## Milldale Stages 10 – 13, 4C & WWTP

Consultation Summary

Fast-track Approvals Act 2024 Substantive Application

26 March 2025

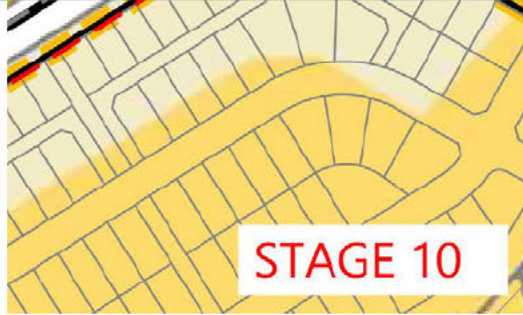
Council Feedback Item	Response
<p>a. Although no ecological assessment was provided for review at the time of writing this memo, a site visit with the applicant's ecologist and subsequent extensive discussion on freshwater matters were undertaken. It is my understanding that the site is characterised by extensive ephemeral wetlands that likely have a low ecological value. These wetlands are acknowledged in the site plans as "Indicative areas affected by non-pasture exclusion wetland delineation as a result of areas of creeping bent grass." The component of these areas that meet the definition of natural inland wetland will not be retained in the layout but will be reclaimed. Additional wetlands will also be reclaimed to accommodate residential densities for Stages 11, 12 and 13. My pre-application advice does not extent to vegetation loss in the riparian yard which is likely to be significant.</p>	<p>This matter has been addressed within the Ecology Report included as <b>Appendices 2C &amp; 4E</b> and <b>Volumes 2 &amp; 4</b> of the AEE.</p>

<p>a. a.1 Reclamation of ephemeral wetlands</p> <p>Discussion with the applicant's ecologist during a site visit highlighted the complexities around delineation of large areas where facultative wetland plant species, together with soil hydrology features may result in these areas meeting the definition of natural inland wetlands. While I acknowledge that these areas may have a low ecological value, in my opinion, these areas serve to hold back water in the soils and have an integral function in the catchment hydrograph. The loss of these extensive ephemeral wetlands to impermeable surfaces associated with paving and buildings, is likely to translate to significant changes to the remaining streams on the site and downstream from the site.</p> <p>The application should assess and address these potential impacts and should provide the necessary mitigation measures in conjunction with stormwater management for the Milldale Precinct. Discussion with the Healthy Waters Consultant Specialist suggests that mitigation for the loss of water storage potential resulting from reclamation of these wetlands is expected to be in addition to the hydrology mitigation requirements (i.e. equivalent SMAF 1) under the SMP, which are limited to the mitigation of future impervious surfaces.</p>	<p>This matter has been addressed within the Ecology Report included as <b>Appendices 2C, 2U, 4E &amp; 4H</b>, and <b>Volumes 2 &amp; 4</b> of the AEE.</p>

6.1.2	<i>Establishment of esplanade reserves</i>

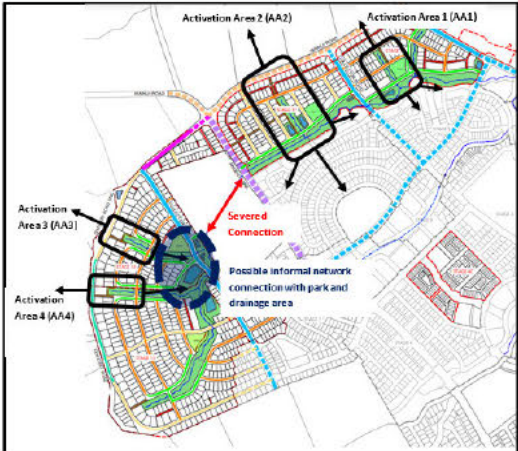
Council Feedback Item		Response
a.	The workshop and provided plans as referenced in section 2 above did not provide any reference to any proposed esplanade reserves to vest. Subject to a stream width confirmation for the relevant streams that dissect the site and subject to accurate surveyor methodology confirmations, esplanade reserve triggers will be determined.	A Stream Width Investigation is provided with the application. Please refer to <b>Appendix 2V</b> .

b.	In reference to s230 of the RMA, this enables Parks Planning to take up to 20m of the esplanade reserve. If a reduced esplanade reserve width is applied, the Parks Planning Team would require a robust assessment of the establishment of the esplanade reserve against E38.3(25). This is required for the proposed width of the esplanade reserve to be sufficient for conservation, as well as for potential future public access. Mitigation in the form of planting is strongly recommended for any width reduction.	The proposed scheme plan is consistent with the stream width assessment. No Esplanade Reserves are proposed.
